ADDENDUM NO. 5

Issue Date: March 19, 2024

Addition and Renovation for: Catawba County Garage

Invitation for Bid No. 24-1019

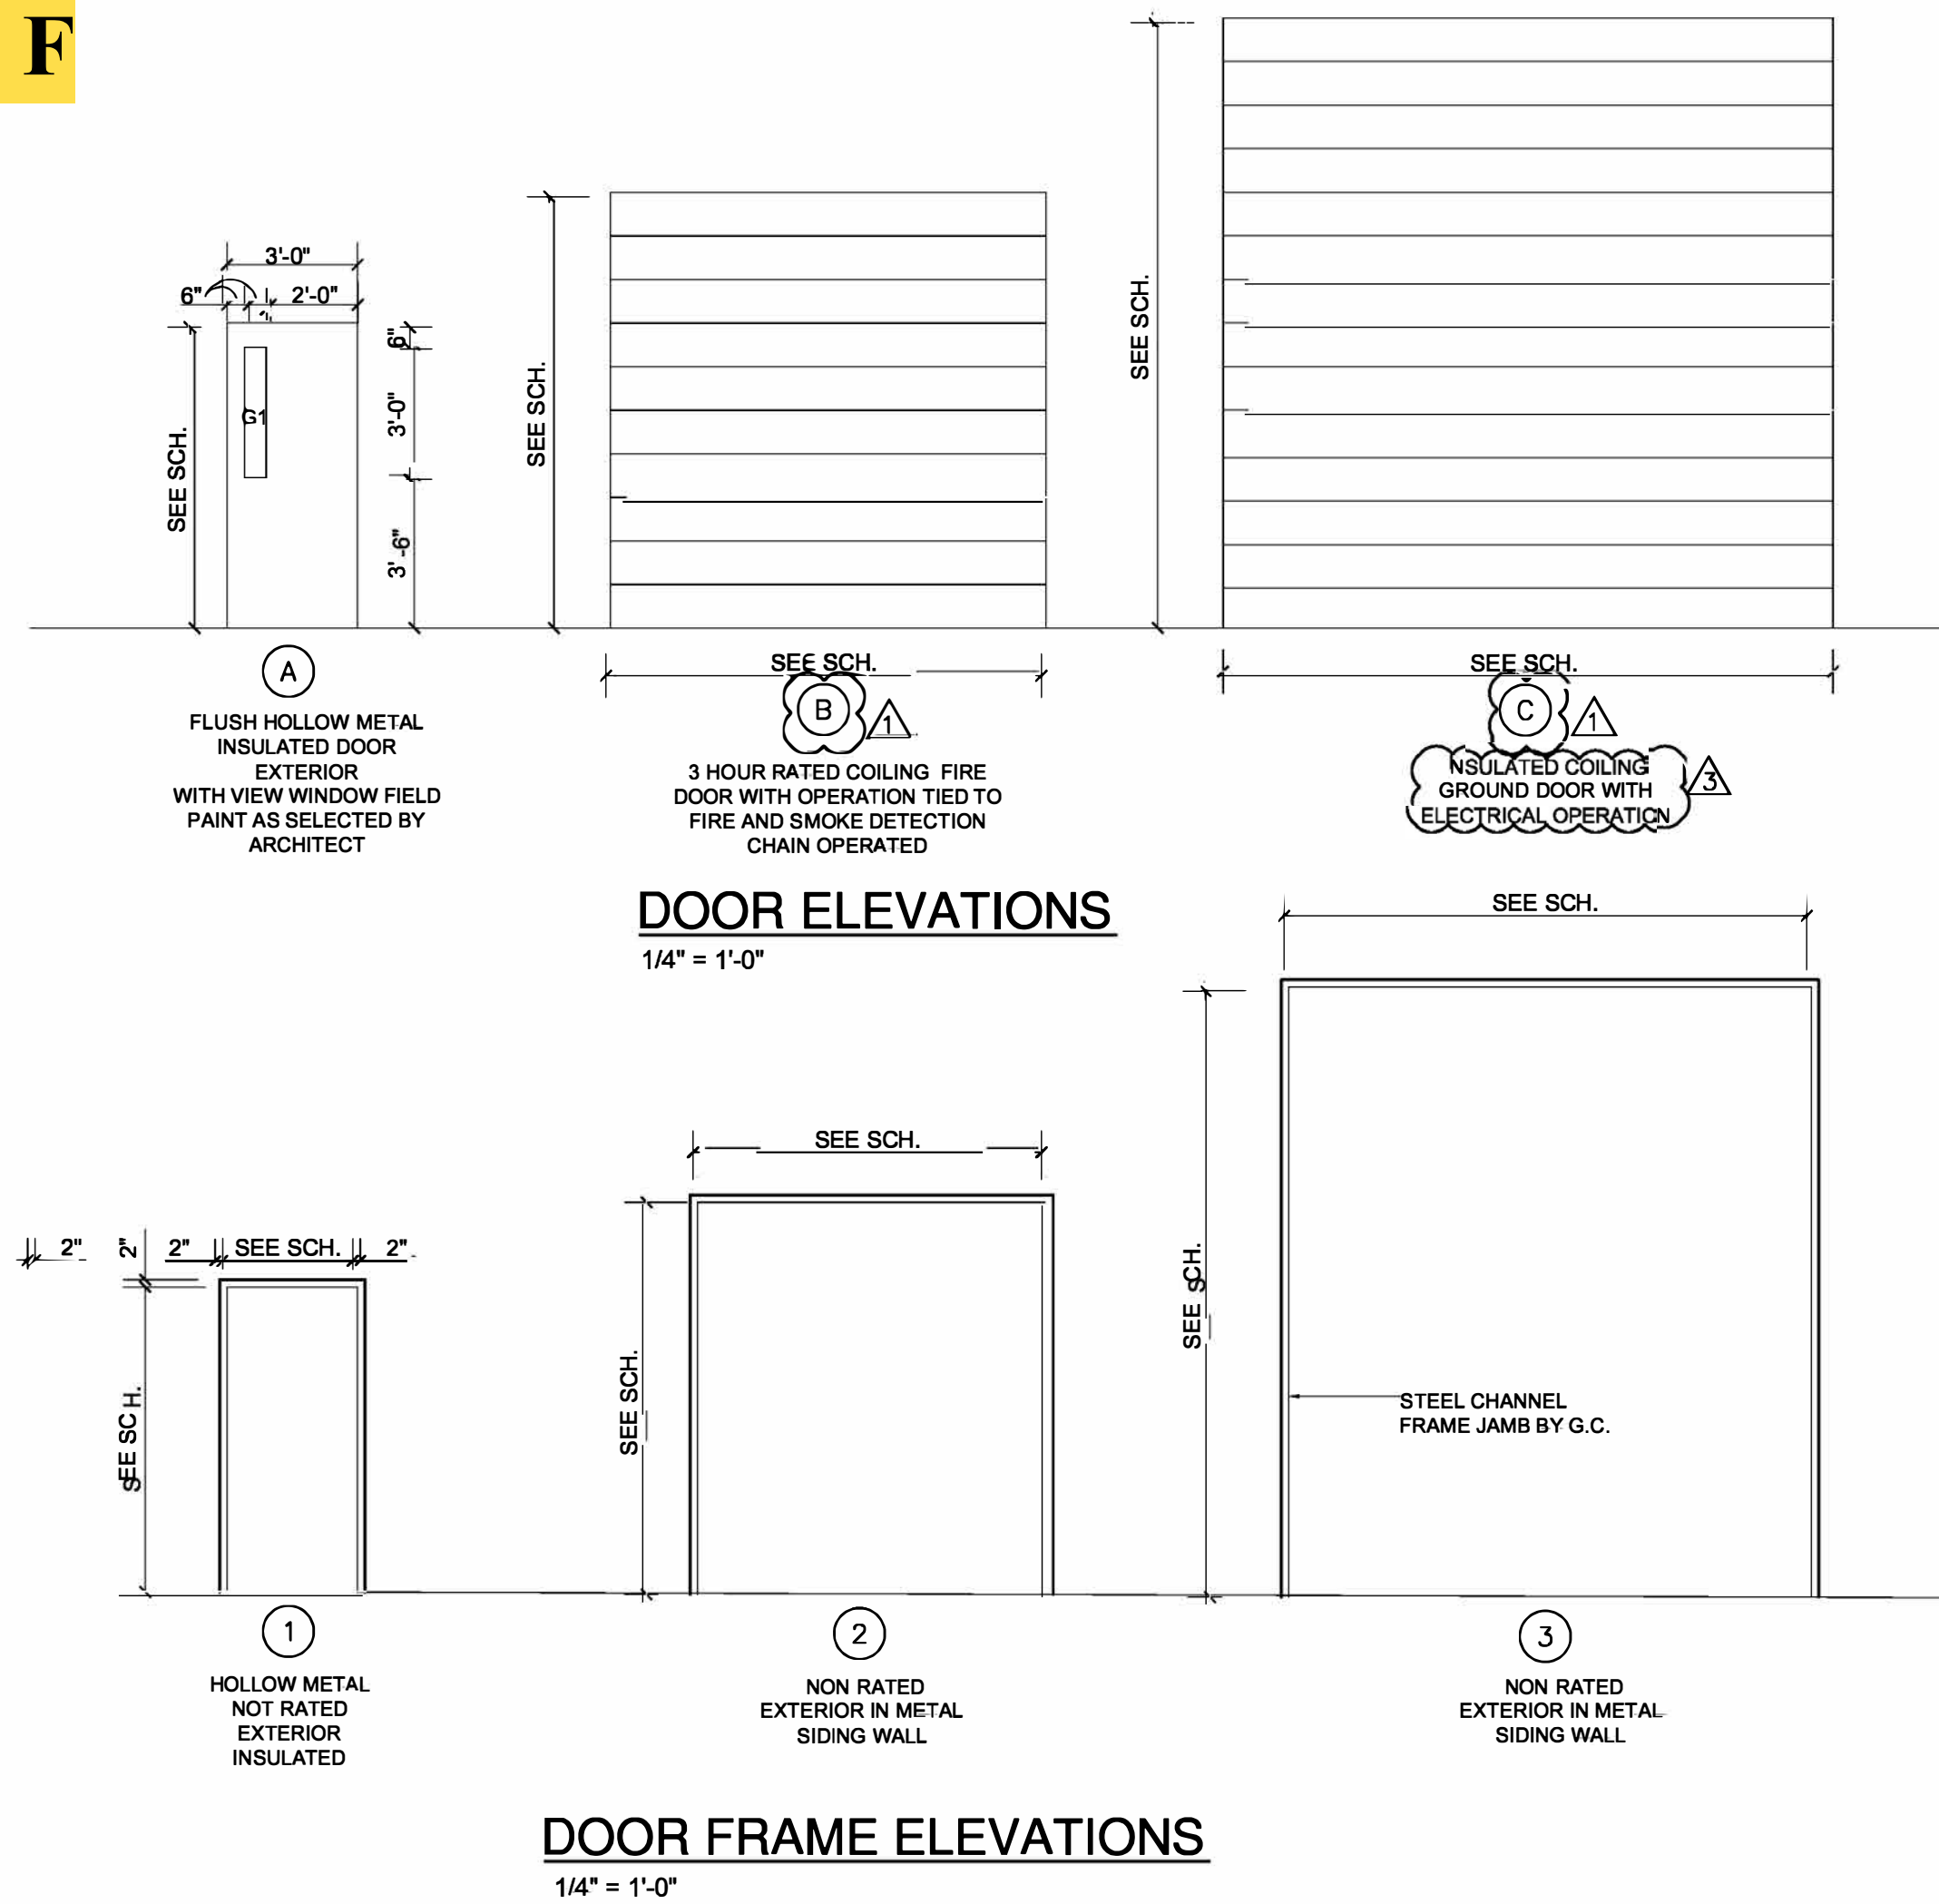
2. **Question:** There are some discrepancies where the wall girts are called 12 gage on Arch drawings and 14 gage on the Structural. Can this be clarified?

Answer: Per architect: In conversation with the structural engineer, Randy Ruggles, it is not as simple as saying all the girts will be 12 or 14 gage. They are specified different gages because of differing spans and wind loading on the building frame. Contractors need to pay attention to the plans and place girts where specified. (Typically – but double check – 12 gage girts are used at 7'-0" AFF at door openings or at long spans. 14 gage girts are used for all other girt applications. The Bent Plates top and bottom of walls will remain 12 gage.

A1.2

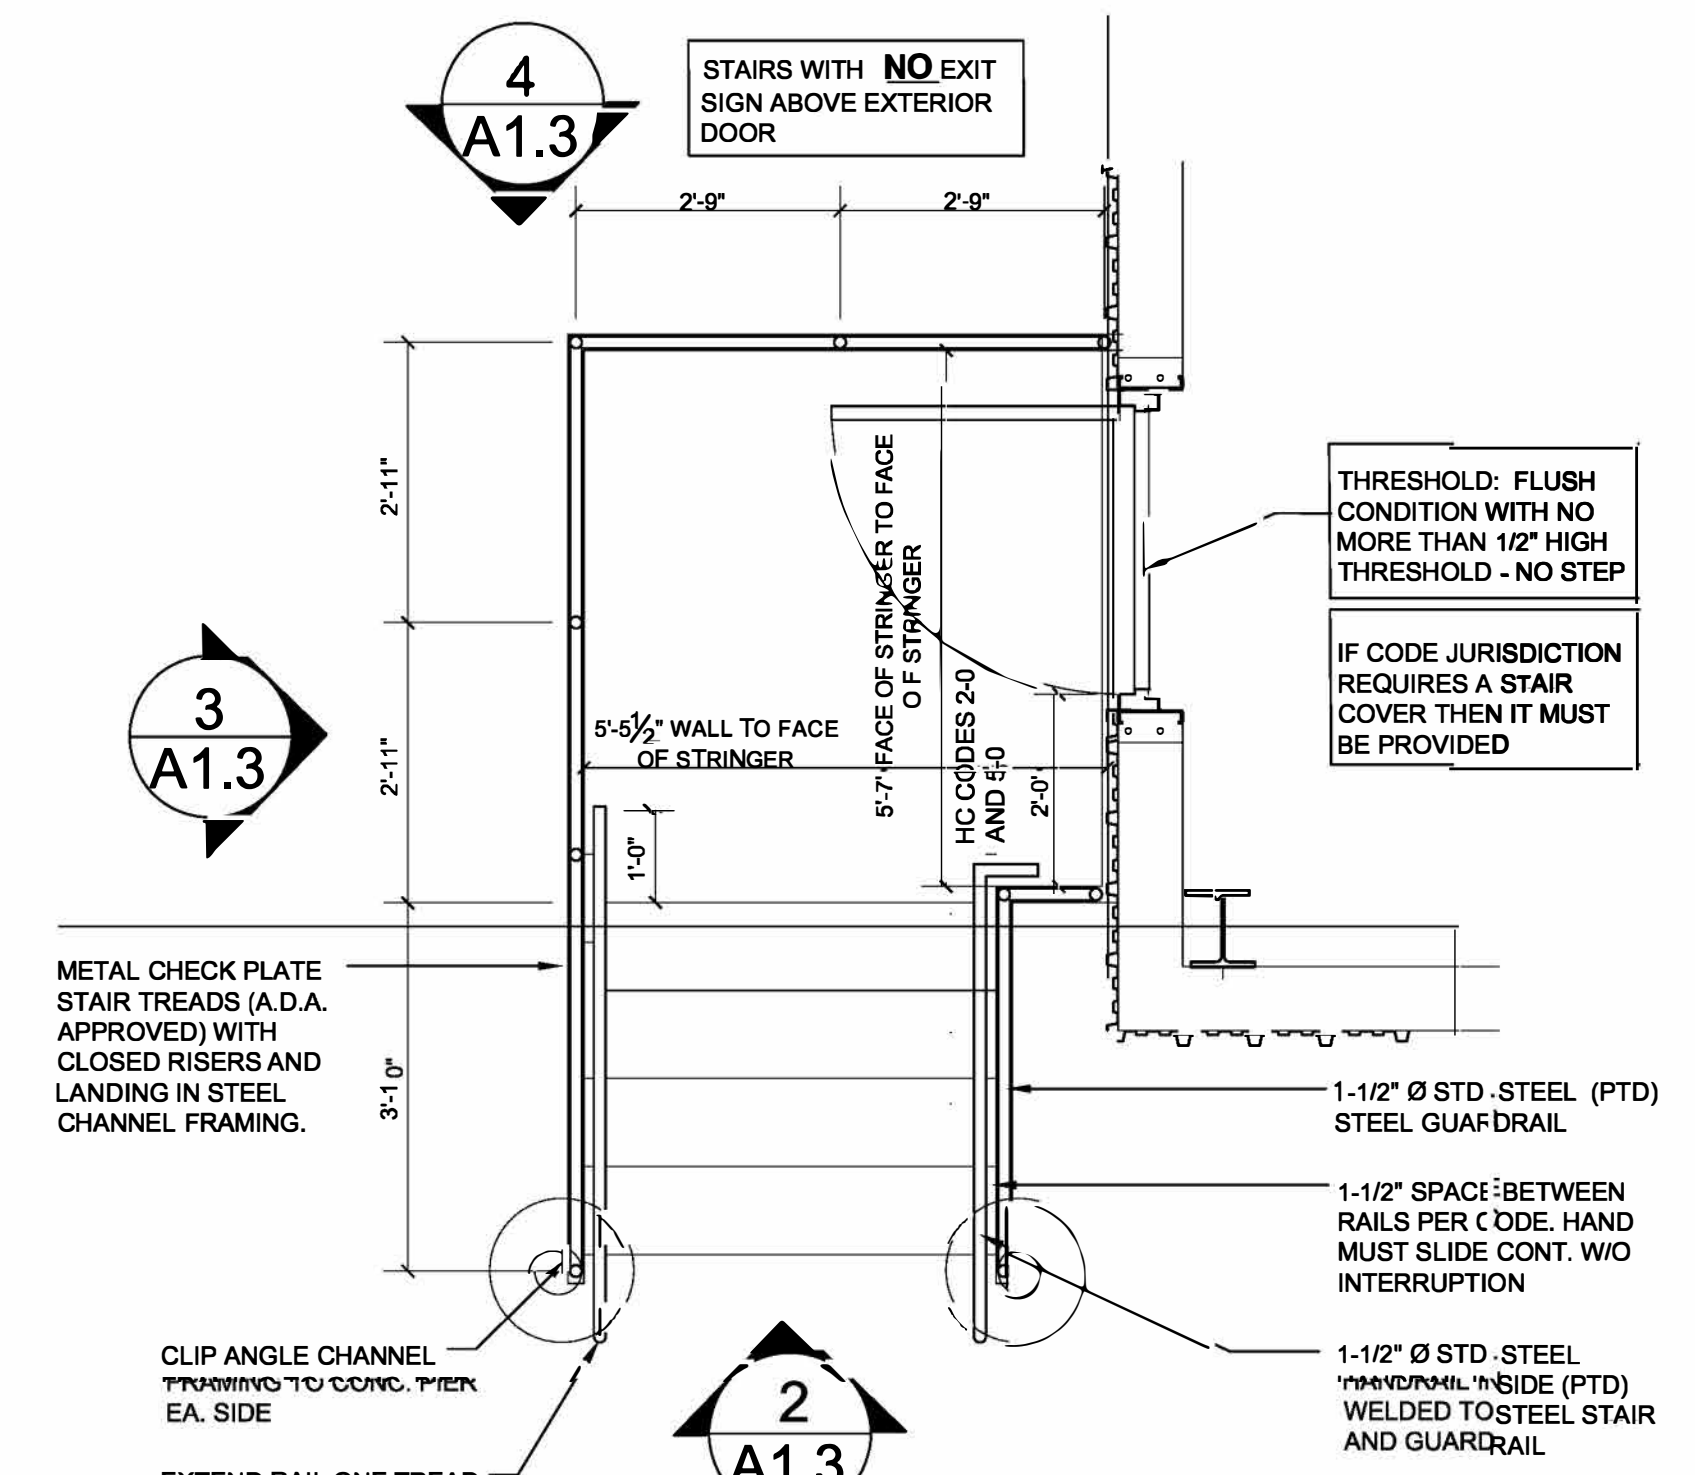
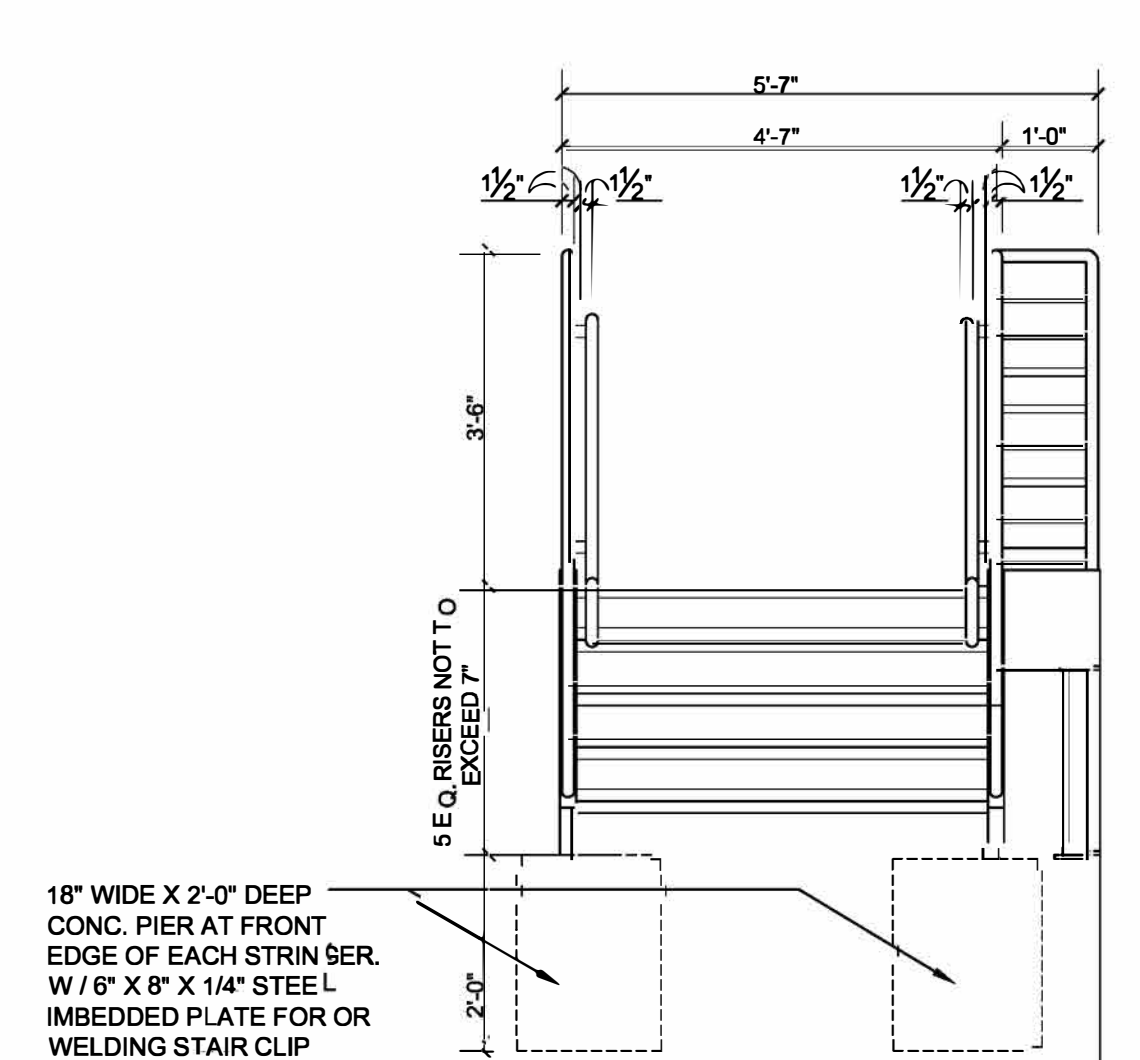
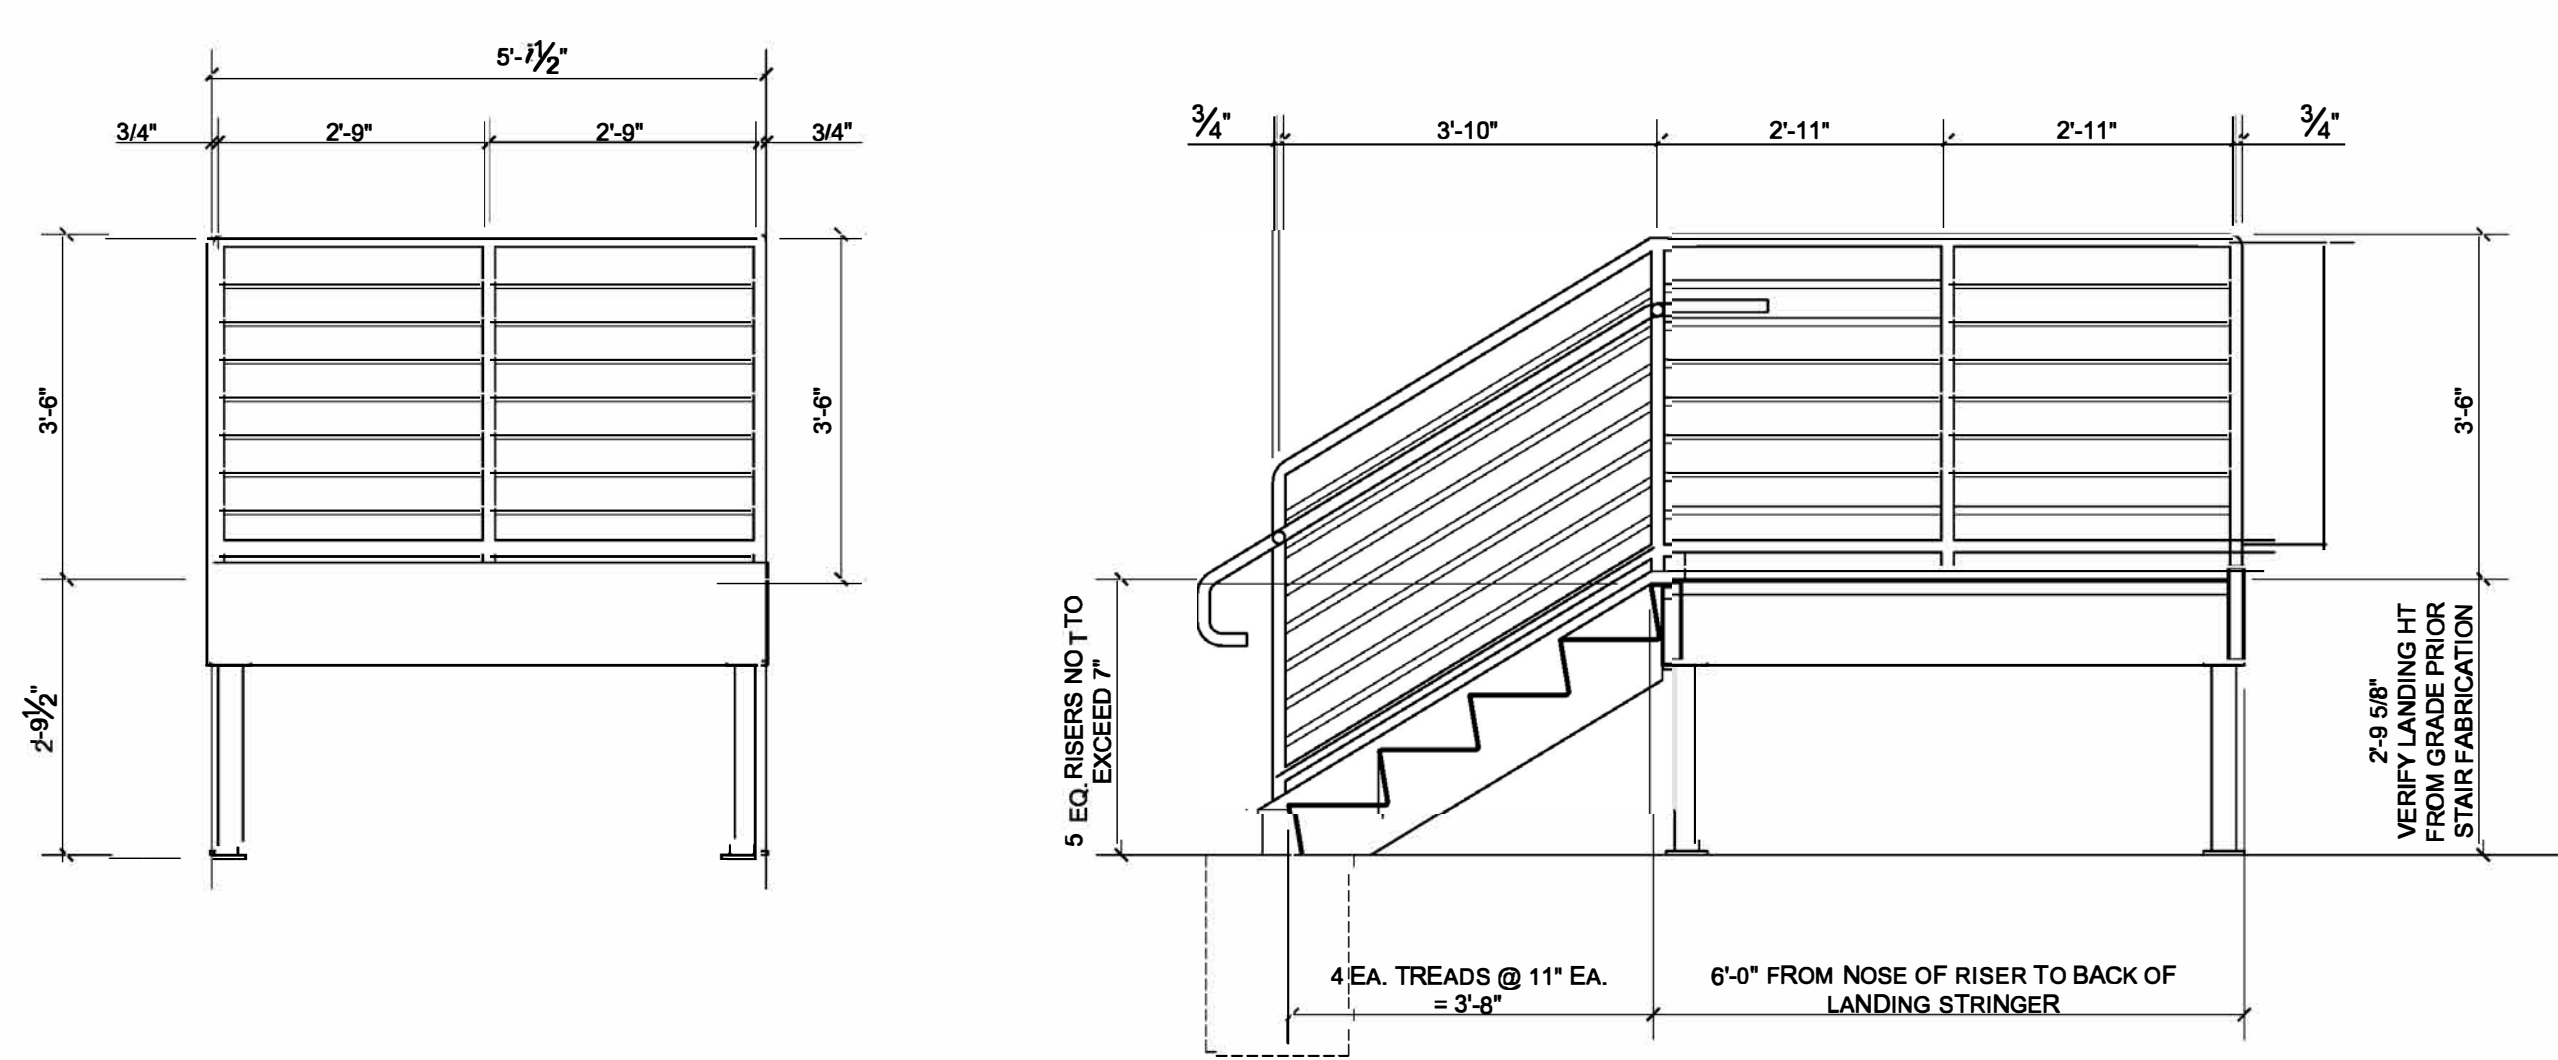
2. Door C was incorrectly identified as a Hi Lift door on Sheet A1.2 prior to this Addendum. The Door should be a coiling Door with an insulating curtain as is now identified in a revised Sheet A1.2, attached hereto as Attachment F.

REVISIONS
CORRECTION FOR DOOR TYPE AND DOOR FRAMES FOR SCHEDULE 03/01/2024
CORRECTION TO CHANGE HI-LIFT TO COILING FOR SCHEDULE 03/14/2024
